REMARKS

Regarding the Drawings

FIG. 2

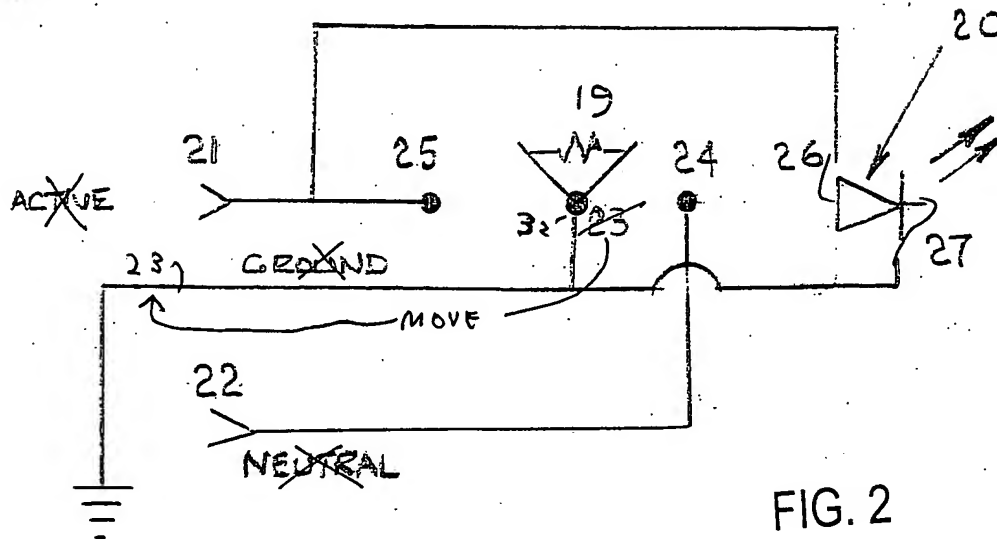
The drawings are objected to under 37 CFR 1.83(a) because they fail to show a properly connected schematic as described in the specification. The objection was directed to Fig. 3, which has now been cancelled. In Fig. 2, the numbering of one component has been changed from 23 to 32 to be consistent with the specification, the label "23" has been moved, and certain text has been deleted.
